STAFF RECOMMENDATION

200 Chapel Avenue

April 17, 2019

Application: New Construction--Infill

Figure 2: Sanborn map from 1957 showing single-family residence with detached outbuilding

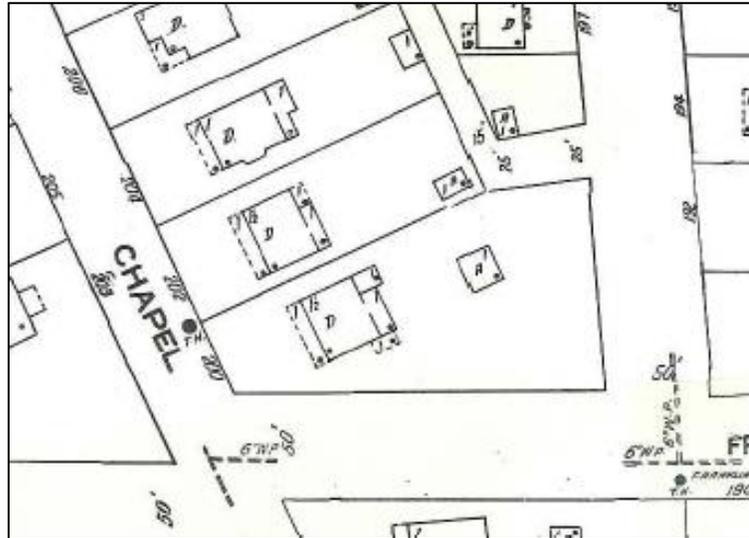
In most cases, when two units are permitted by base zoning, they should be in one building as seen historically to maintain the rhythm of the street. In 1957, the lot had a house oriented to Chapel Avenue with an outbuilding (Figure 2).

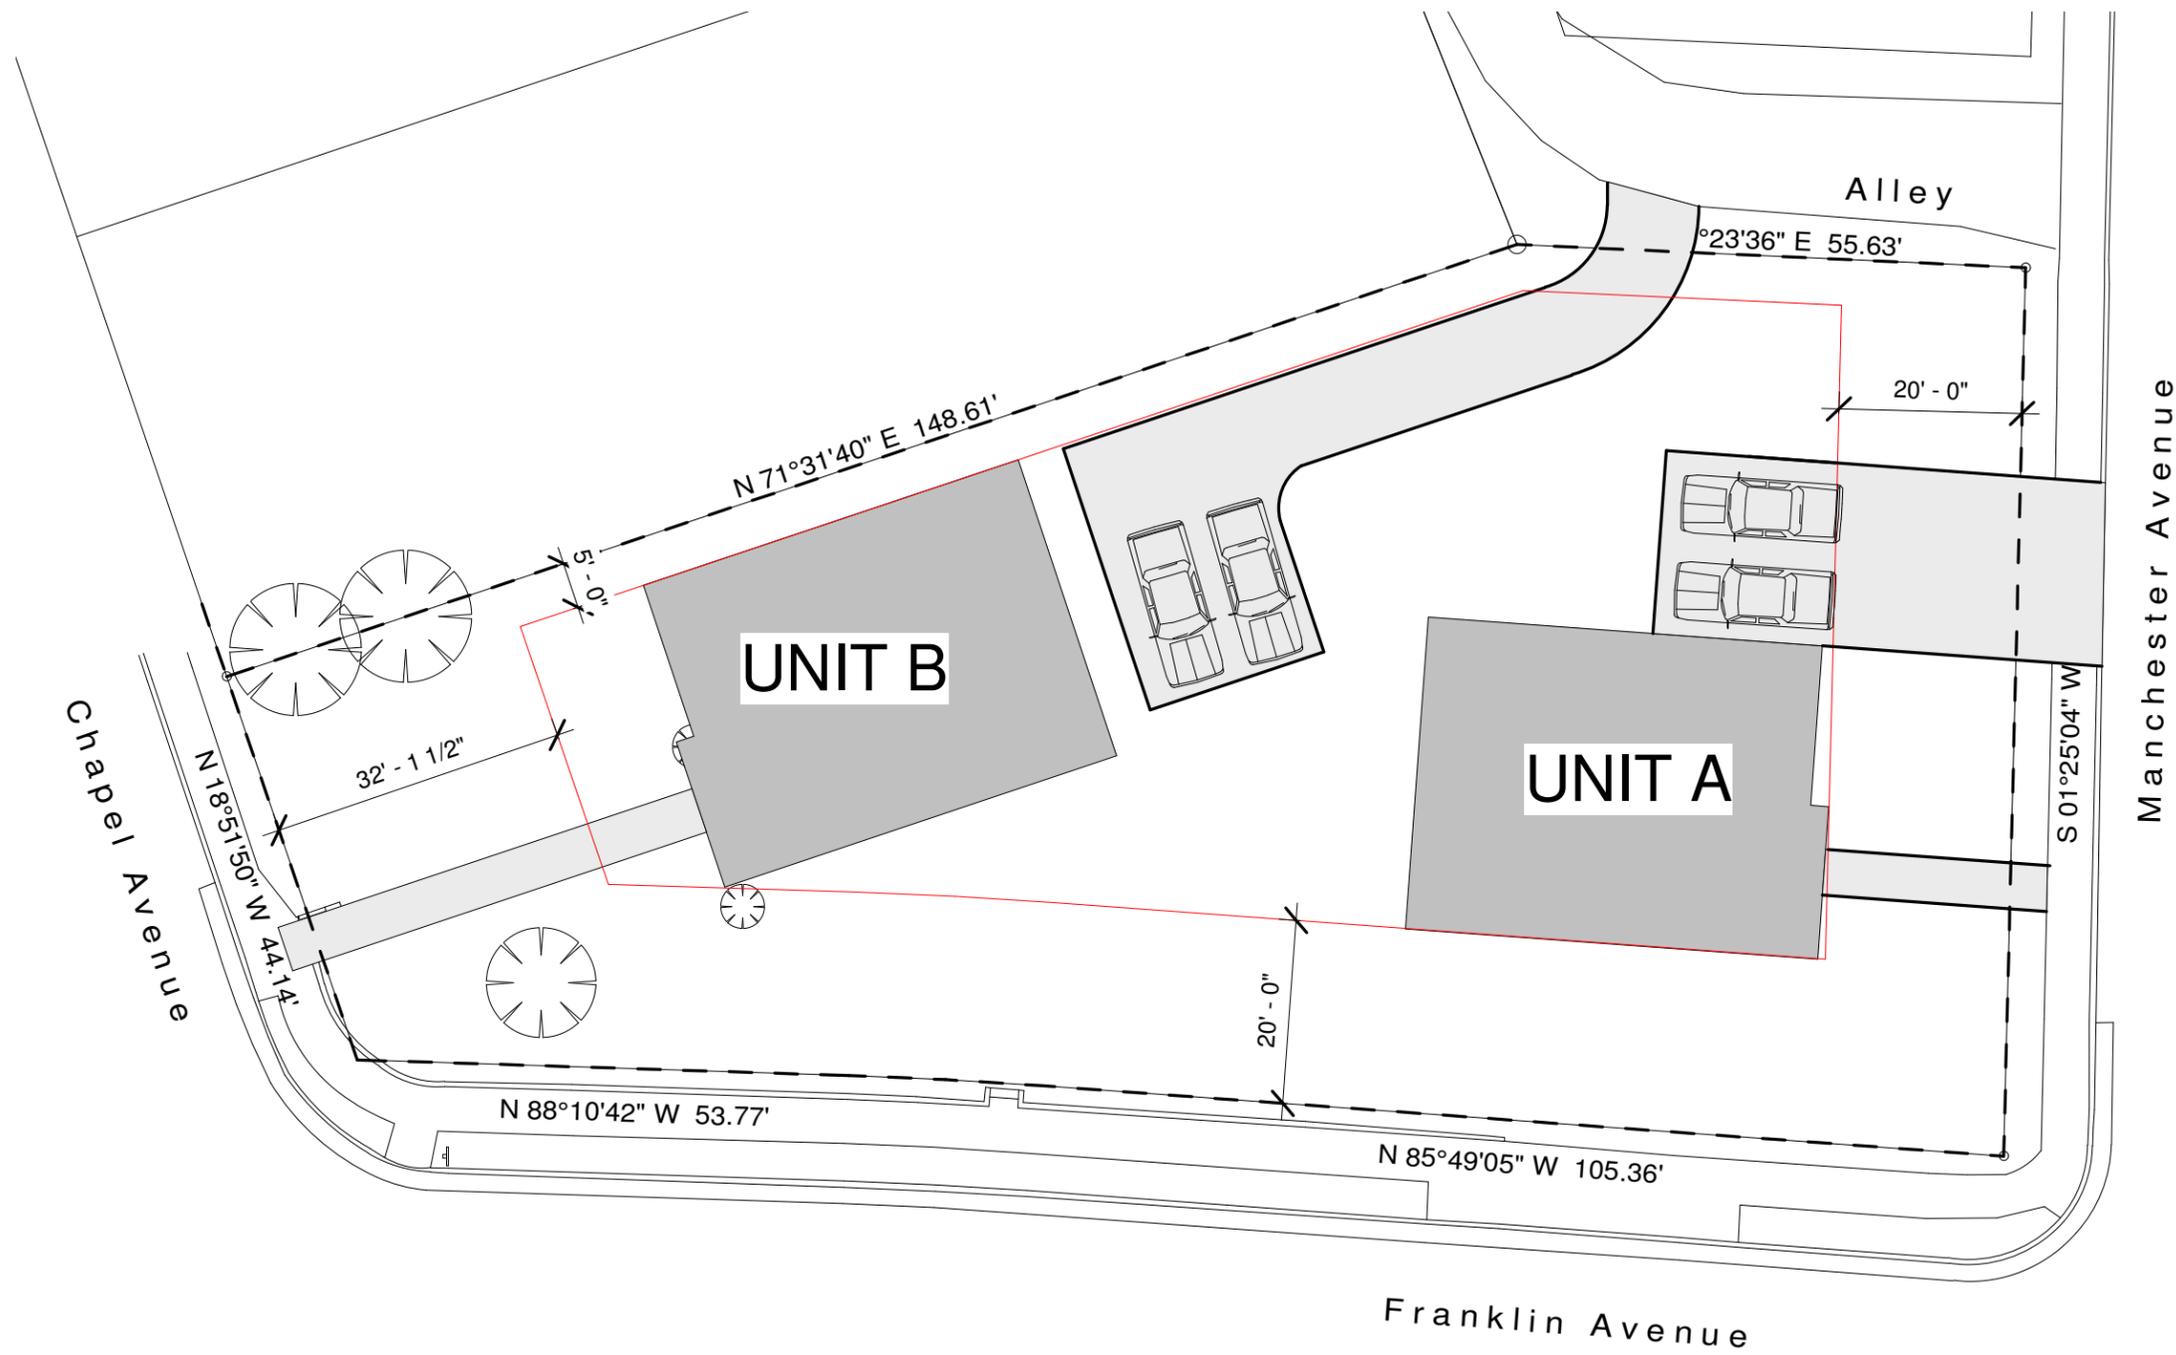
Orientation: Unit B is oriented toward Chapel Avenue and includes a partial width front porch that is six feet, six inches (6' 6") deep. A walkway connects the house to the street. For a single building on the lot, this would be consistent with the historic context and meets section II.B.1.f. However staff finds that Unit A is not consistent with the rhythm of spacing in this vicinity. Historically this lot had one primary structure oriented to Chapel Avenue.

Vehicular access for Unit B is from an alley off Manchester Avenue. Vehicular access for Unit A is wide driveway from Manchester Avenue that terminates with parking at the front-side of the house. Typically, the Commission does not approve new curb cuts, but when they have been necessary they have been kept at ten to twelve feet (10'-12') in width to minimize their impact. A scale was not provided on the site plan, but the driveway appears to be double the appropriate width.

The project does not meet section II.B.1.f of the design guidelines for Orientation.
